Thanet Extension Offshore Wind Farm

Appendix 14 to the Deadline 4 Submission - Structures Exclusion Zone

Date: March 2019

Revision A

Figure 1: Amendment - Structures Exclusion Zone

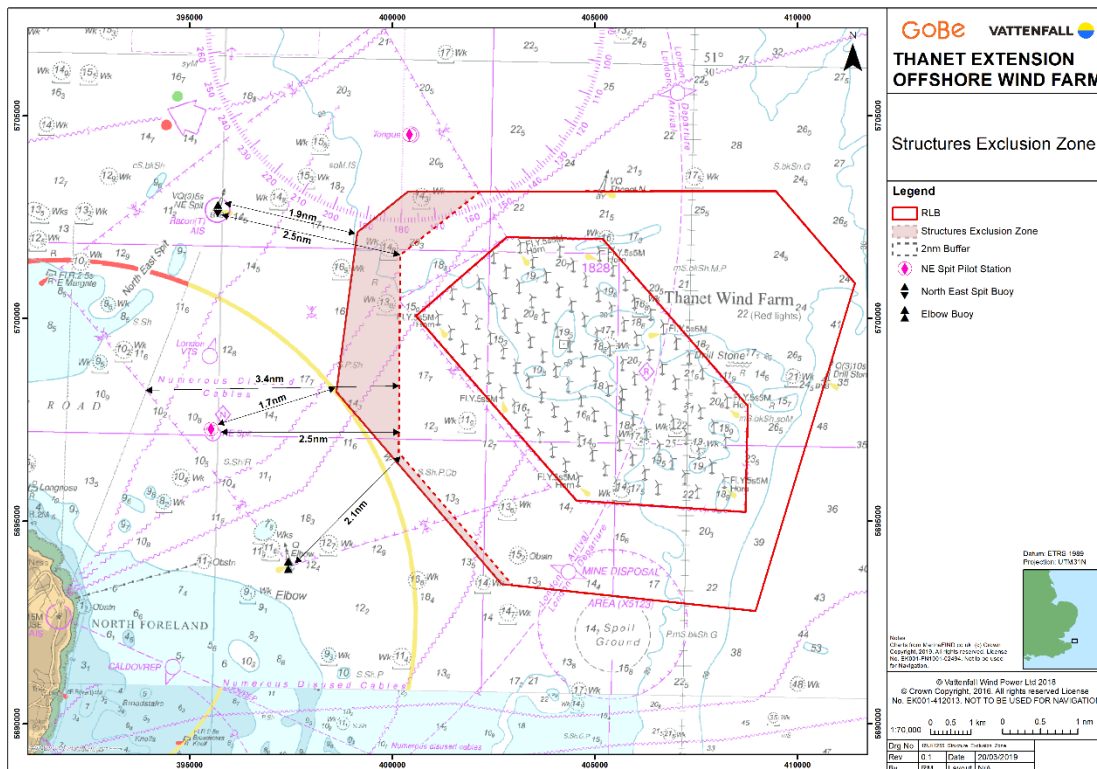
- 12 The SEZ is shown at Figure 1. Table 2 relates the key distances shown in Figure 1 to specific reference locations (as detailed in Section 3 and agreed with IPs). As a result the amendment provides additional area to the north west, west and south west faces of the wind farm for marine activities.

Reference Location	Distance to RLB (nm)	Distance to SEZ (nm)	Increase in distance (nm)
NE Spit Buoy	1.9	2.5	0.6
NE Spit PBS*	1.7	2.5	0.8
Elbow Buoy	2.0	2.1	0.1
Tongue PBS	0.8	1.2	0.4

Figure 4: Sea Room between NE Spit Buoy and SEZ

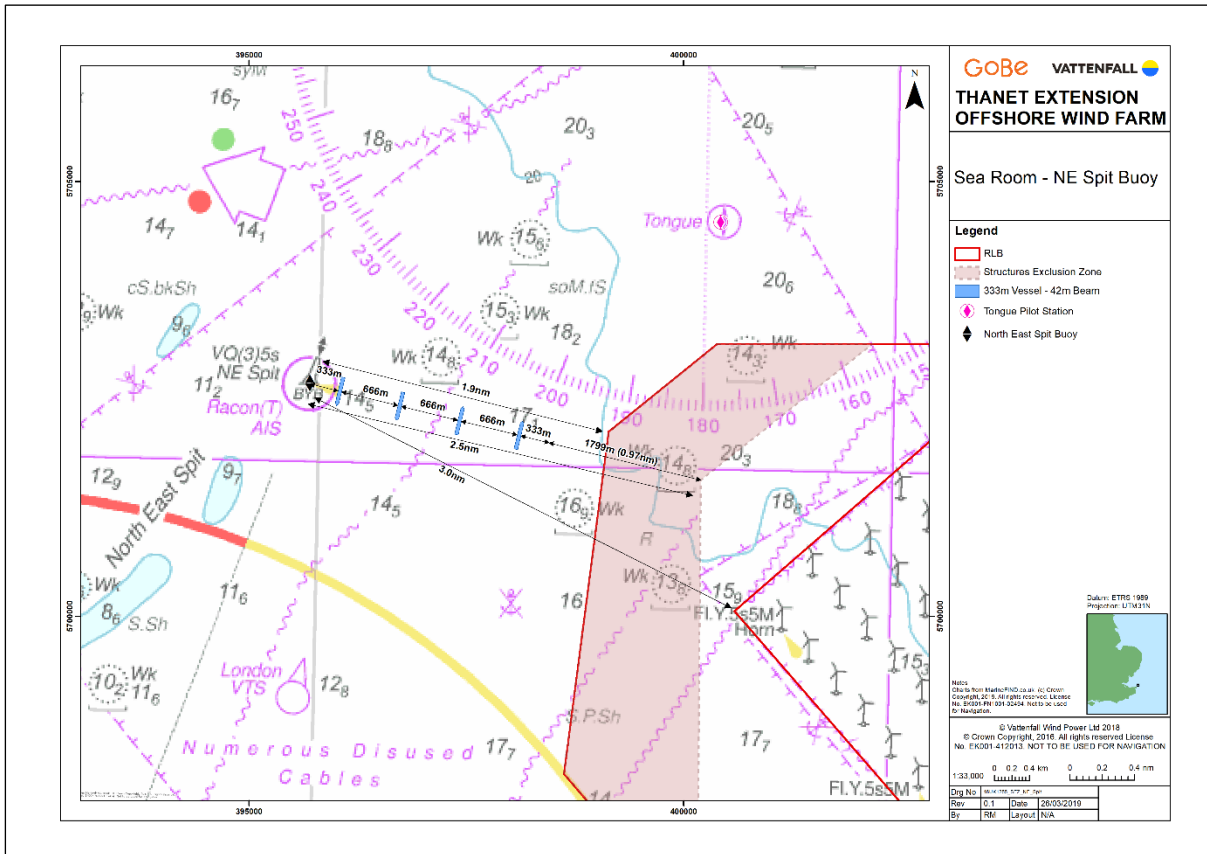
- 41 The amendment, as shown in Figure 4, creates a minimum total clear distance of 2.5nm between NE Spit Buoy and the SEZ boundary noting that the current distance between NE Spit Buoy and the existing wind farm is 3.0nm.
- 42 The minimum sea room requirement, as per the MSP guidance (as shown in Table 12 for four side by side vessels of 333m LOA) specifies 1.53nm required sea room leaving a further 0.97nm distance available as sea room and safety buffer in recognition of the more complex vessel tracks and manoeuvres, and the level of fishing transits across this area, as described in IP responses.
- 43 The north western face of the TEOW WTG has been aligned more closely with the predominant track of vessels transiting towards the NE Spit Pilot Boarding Station Diamond in order to minimise course deviation and heading alterations.

Vessel Length (m)	Sea Room required for no of vessels Side by Side [nm]			Remaining Sea Room available at location for consideration as a buffer [nm]		
	2 Vessels	3 Vessels	4 Vessels	2 Vessels	3 Vessels	4 Vessels
299	0.70	1.05	1.40	1.80	1.45	1.10
333	0.76	1.15	1.53	1.74	1.35	0.97
366	0.86	1.28	1.71	1.64	1.22	0.79
400	0.93	1.39	1.86	1.57	1.11	0.64

Figure 5: Sea Room at NE Spit Pilot Boarding Station

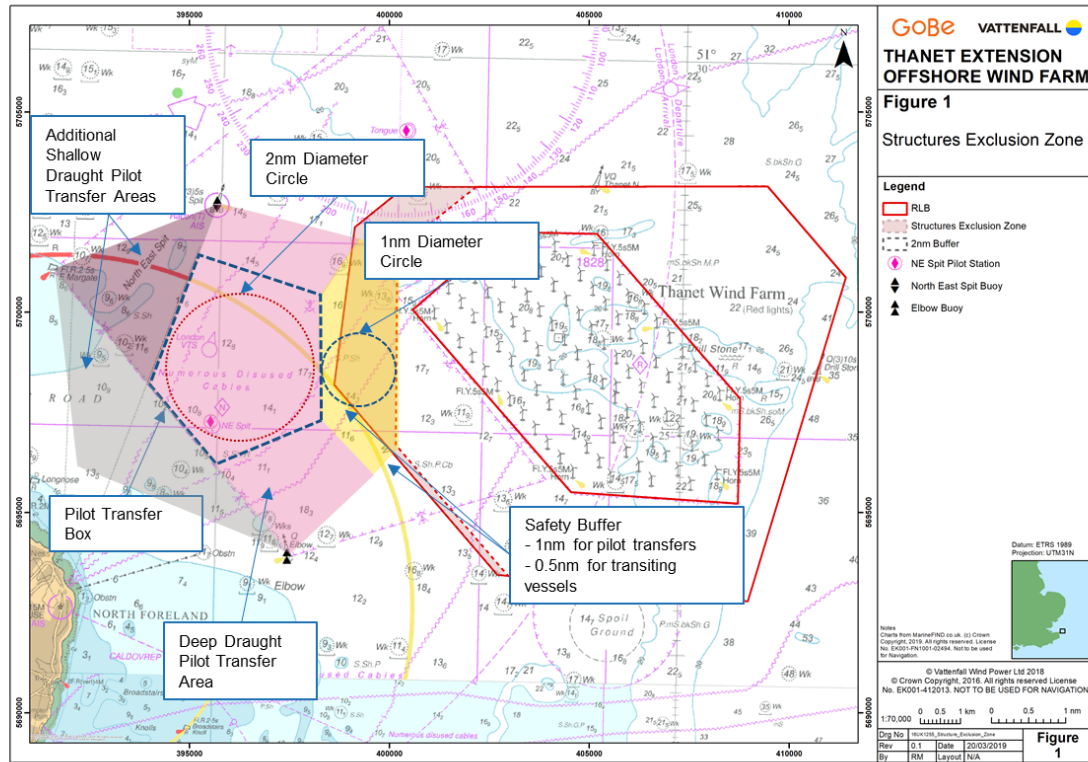
- 47 The amended boundary, as shown in Figure 5, results in the closest point of the SEZ to the NE Spit Pilot Boarding Station of 2.5nm (with a further 0.33nm to the anchorage limit) and a larger 3.4nm width at its widest, just north of this point, in the area of greatest concentration of pilot transfers and complexity of navigation.

- 48 A precautionary approach to defining the stated distances has been adopted by using the NE Spit Pilot Station diamond location which is located to the east (inside) the western extent of the no anchoring area (as shown in Figure 5).

- 49 A precautionary approach to determination of areas has been undertaken by consideration of the largest vessels (those constrained principally by draught and length) in defining areas. These are considered to be restricted to the area marker 'pilot transfer box' in Figure 5 and the boundary is defined by the no anchoring area and the North Foreland sector light. However it should be noted that pilotage does routinely occur (for vessels of suitable draught and length) to the west of this boundary, when safe to do so, and also to the north west of the sector light (as shown in Figure 5 and marked 'additional shallow draught pilot transfer areas') which collectively represents a considerable area.

- 51 A minimum safety buffer of 0.5nm is provided (for transiting vessels) together with a more precautionary 1.0nm buffer for vessels undertaking pilot transfers.

Figure 6: Sea Room at NE Spit Pilot Boarding Station and ESL Vessel Activity

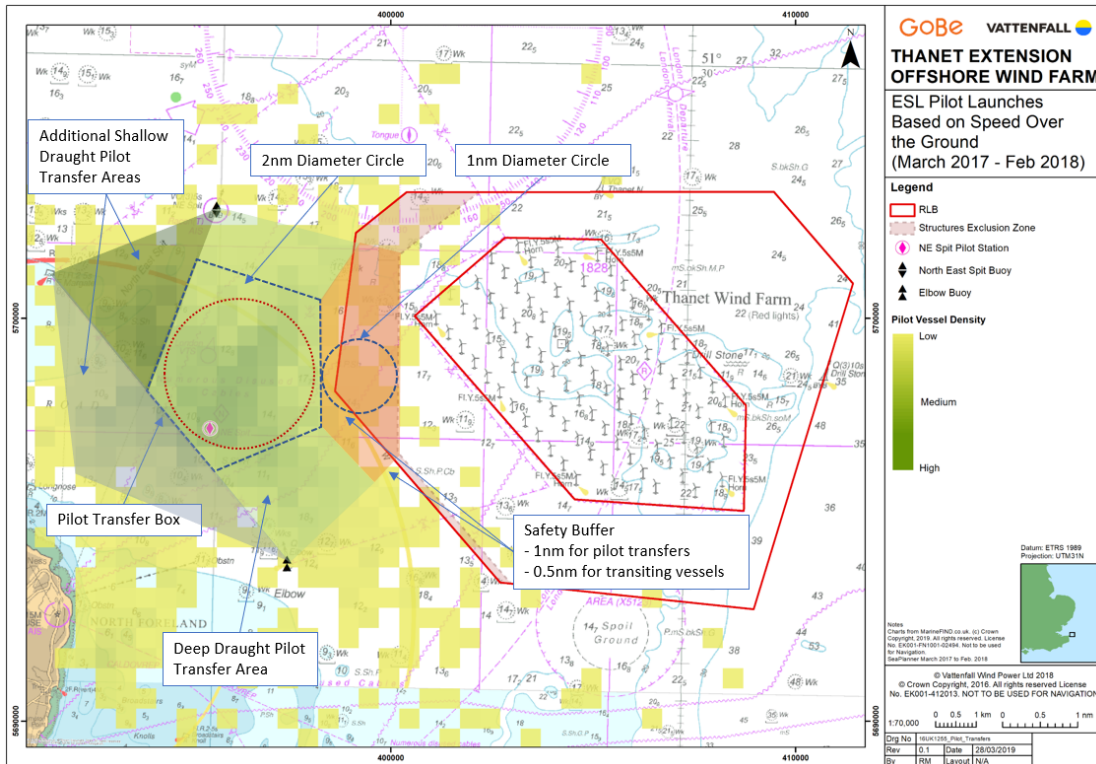
- 50 The basis of the amendment is to ensure a minimum of 2nm of sea room in recognition of the submission as provided by LPC, ESL and PLA and in conjunction with the guidance and evidence from the data representing existing pilot transfers. The re-alignment of the western face opens the available sea room significantly beyond 2nm in the area of greatest activity of transfers and this is evidenced by the data in Figure 6 showing overlay of ESL activity with the SEZ and the pilot transfer areas.

Figure 7: Sea Room between Elbow Buoy and SEZ

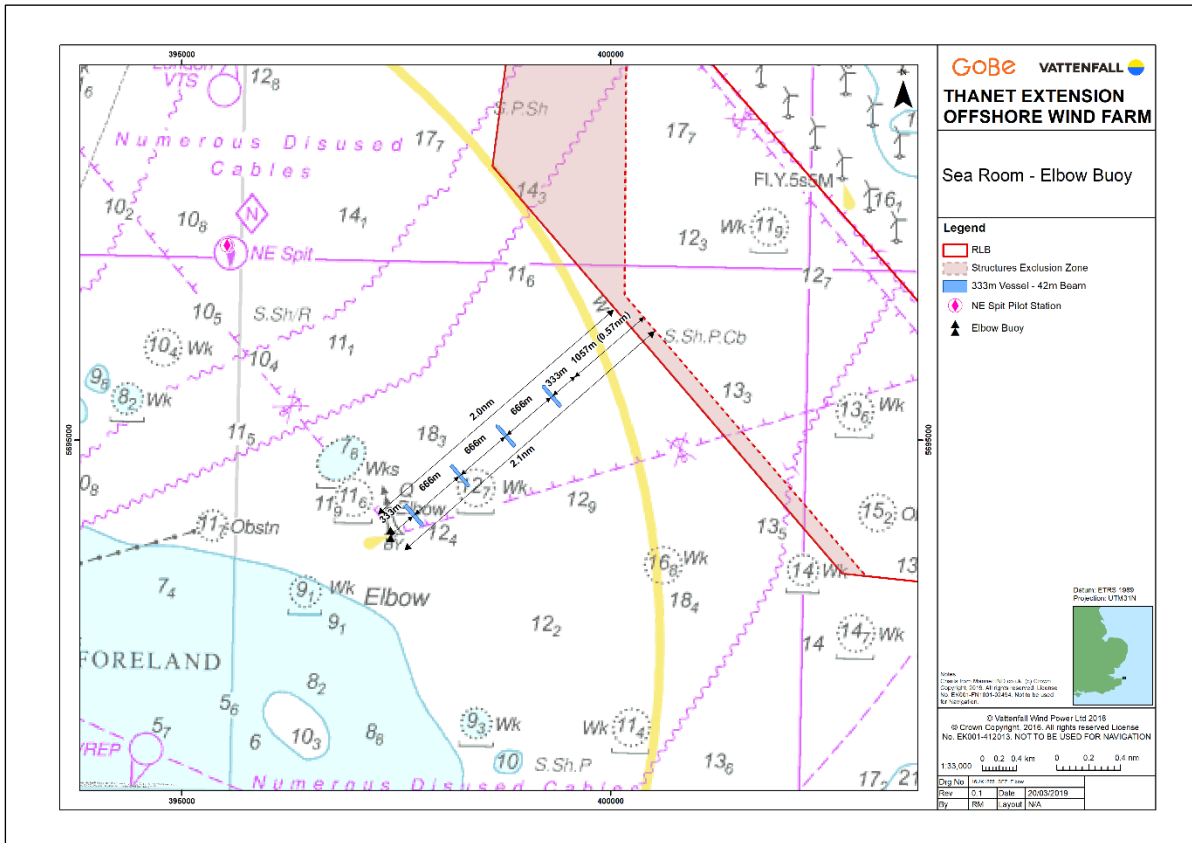
- 55 The amended boundary, as shown in Figure 7, creates a total distance of 2.1nm between Elbow Buoy and the SEZ.
- 56 A precautionary approach has been taken through consideration of this as the narrowest point on the inshore route, noting that the sea room either side of this alignment widens out considerably to the north (particularly in light of the changes made at NE Spit Pilot Station) and to the south towards NE Goodwin Pilot Boarding Station. This significantly increases the line of sight for vessels transiting between the Elbow Buoy and the wind farm reducing any sense of narrowing and allowing the mariner to appreciate the sea room beyond this point when coming from the south.

- 57 The minimum sea room requirement, as per the MSP guidance (as shown in Table 12 for four side by side vessels of 333m LOA which is highly precautionary given the number of vessels per annum) specifies 1.53nm required sea room leaving a further 0.57nm distance available as sea room, thereby incorporating a minimum 0.5nm safety buffer.

Vessel Length (m)	Sea Room required for no of vessels Side by Side [nm]			Remaining Sea Room available at location for consideration as a buffer [nm]		
	2 Vessels	3 Vessels	4 Vessels	2 Vessels	3 Vessels	4 Vessels
299	0.70	1.05	1.40	1.40	1.05	0.70
333	0.76	1.15	1.53	1.34	0.95	0.57
366	0.86	1.28	1.71	1.24	0.82	0.39
400	0.93	1.39	1.86	1.17	0.71	0.24
